**OHIO TURNPIKE AND
INFRASTRUCTURE COMMISSION**

ADDENDUM NO. 2

PROJECT NO. 39-18-02

**PART A - MAINLINE PAVEMENT RECONSTRUCTION, MILEPOST 169.74 TO MILEPOST
176.34, SUMMIT AND CUYAHOGA COUNTIES, OHIO**

13
727

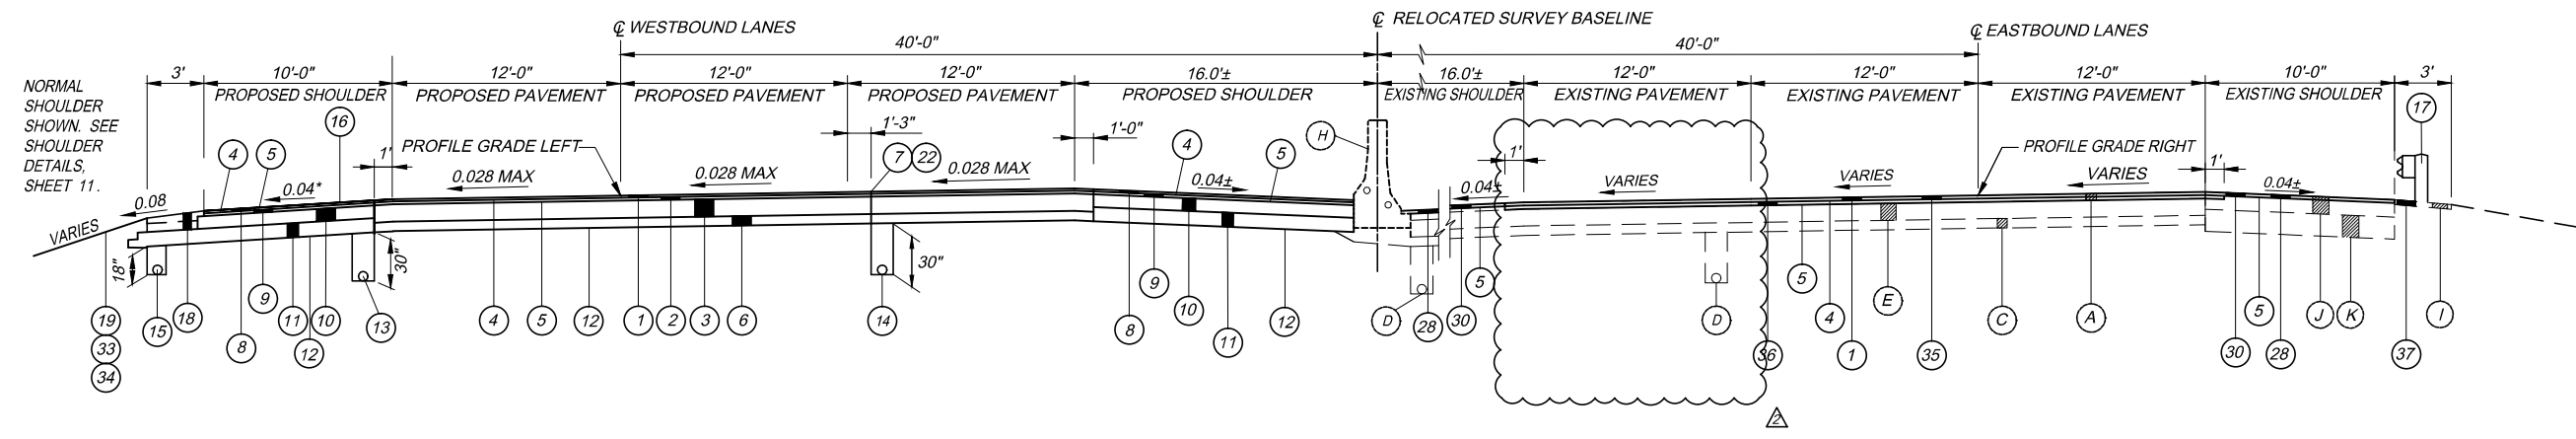
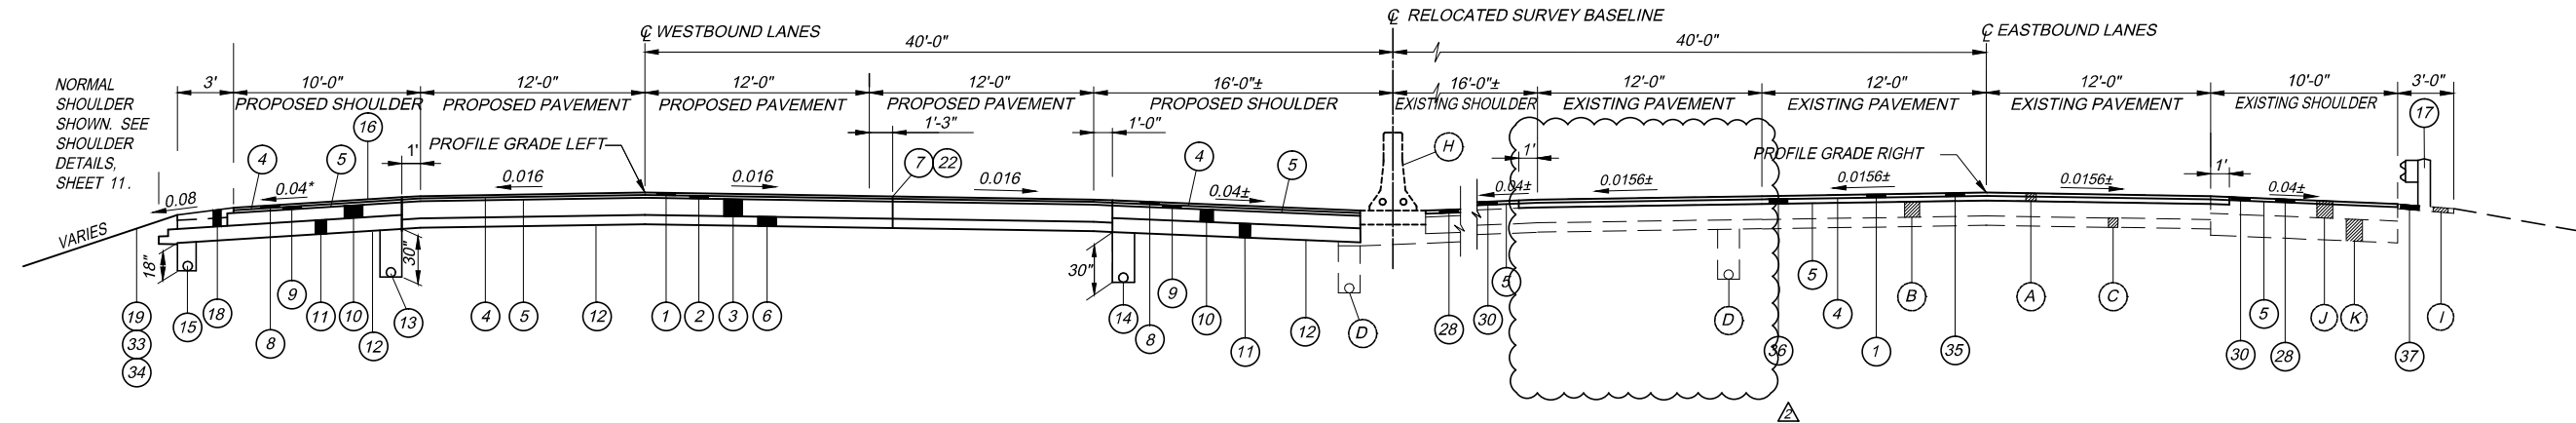
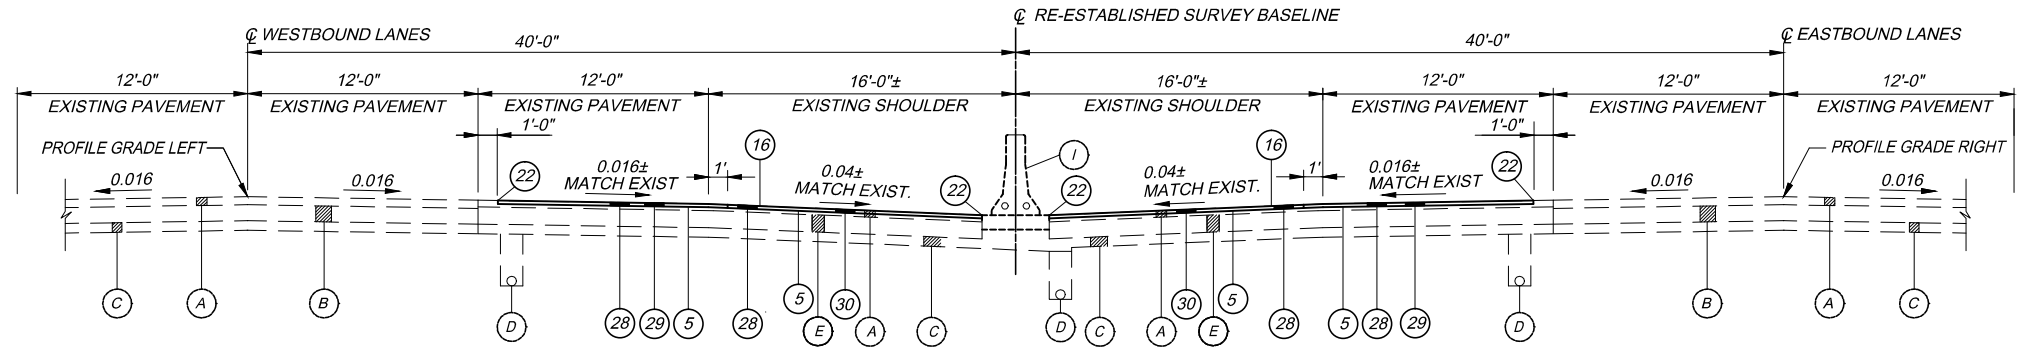
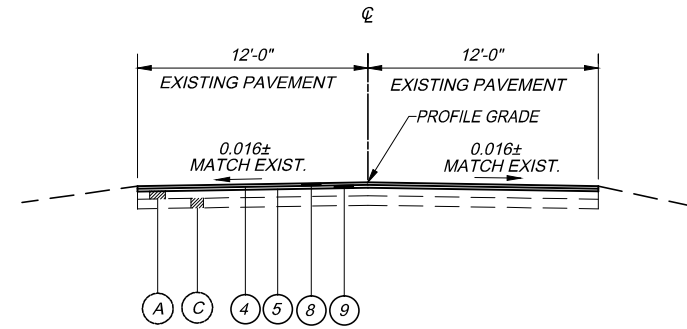
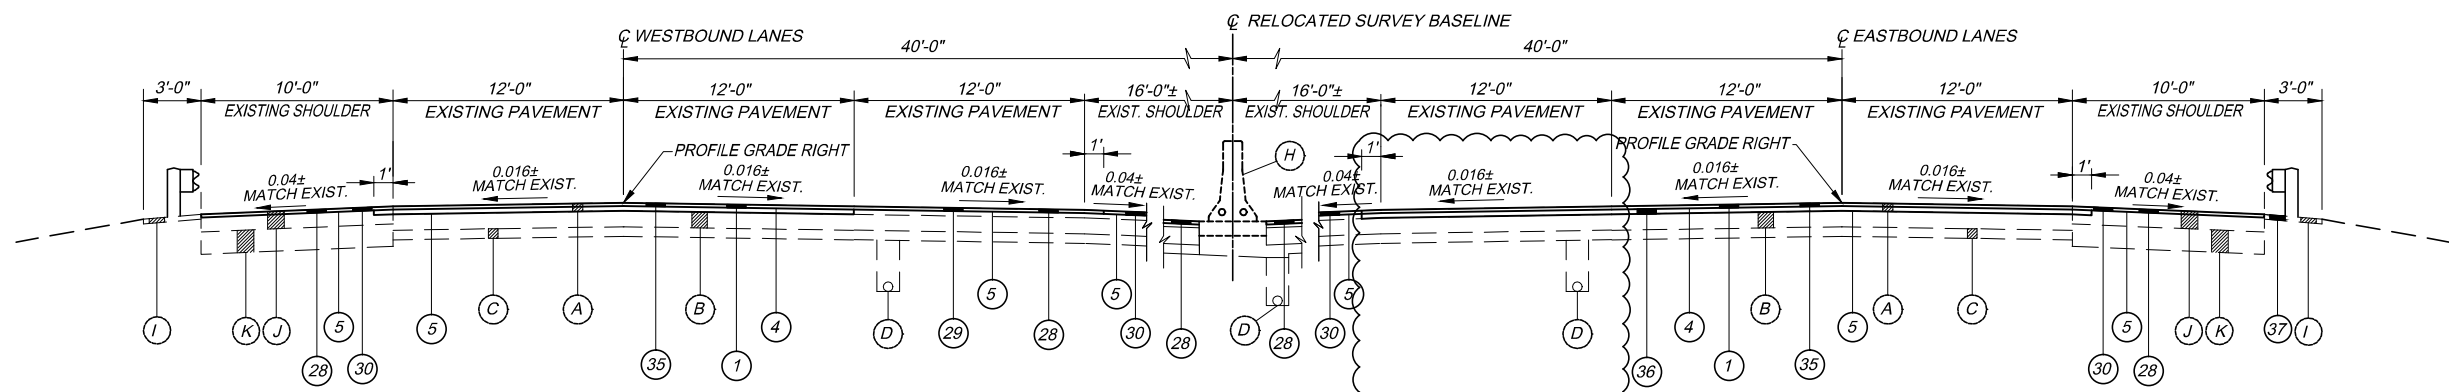
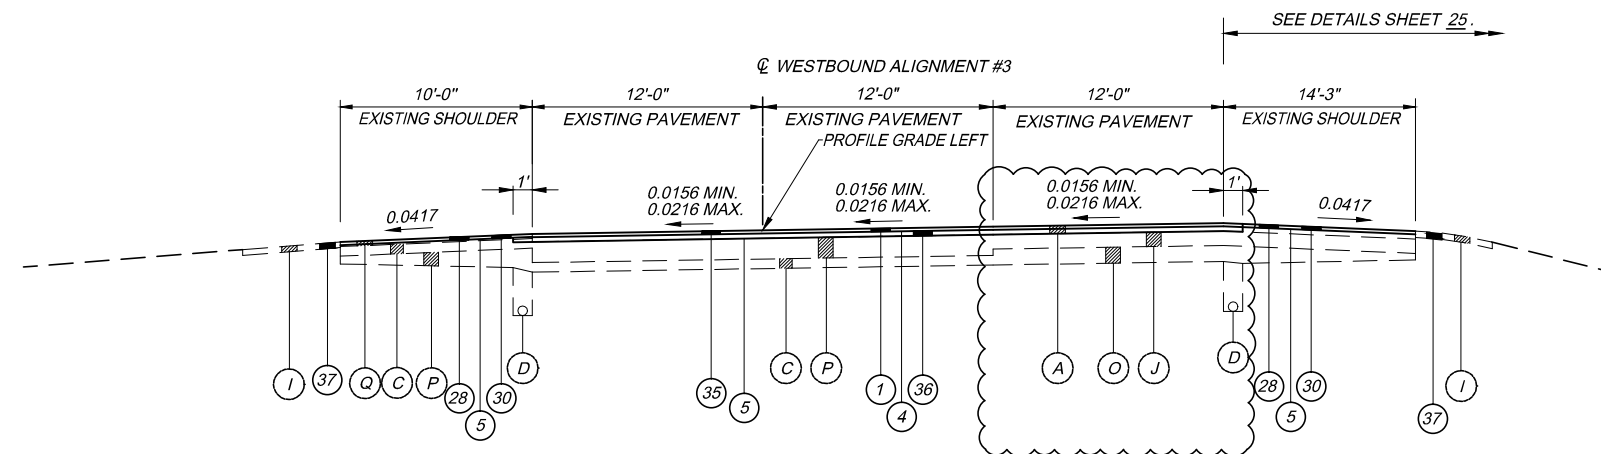
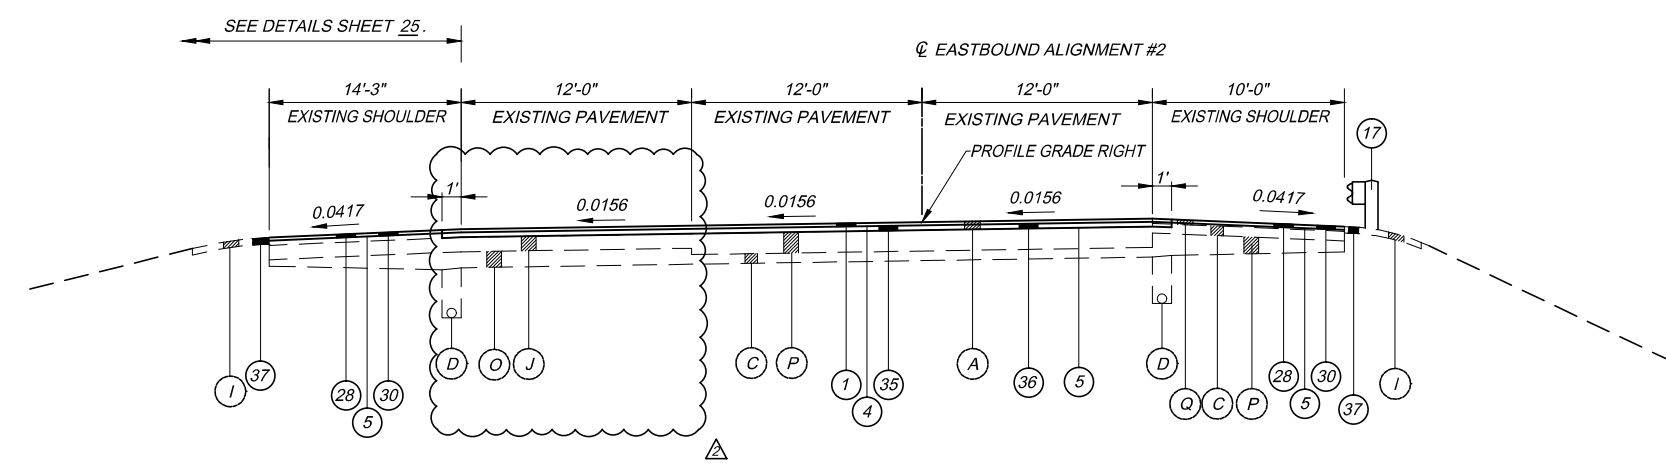
Q#52 The Typical Section on Sheet 13 for the resurfacing of the Eastbound lanes/shoulders, the Typical Section on Sheet 25 for the resurfacing of the Westbound lanes/shoulder, and the bottom Typical Section on Sheet 24 for the resurfacing of both Eastbound & Westbound lanes/shoulder show the milling depth for the 3rd Lane to be 2” (callout 28) but the calculated quantities for 254 Pavement Planing and SP402 Intermediate, SP76-22 do not reflect this. Please review and clarify the resurfacing in the 3rd Lane.

A#52 This Addendum No. 2 revises Typical Section Plan Sheets 13, 24 and 25 of 727 to match the calculations in the Pavement Sub-summary.
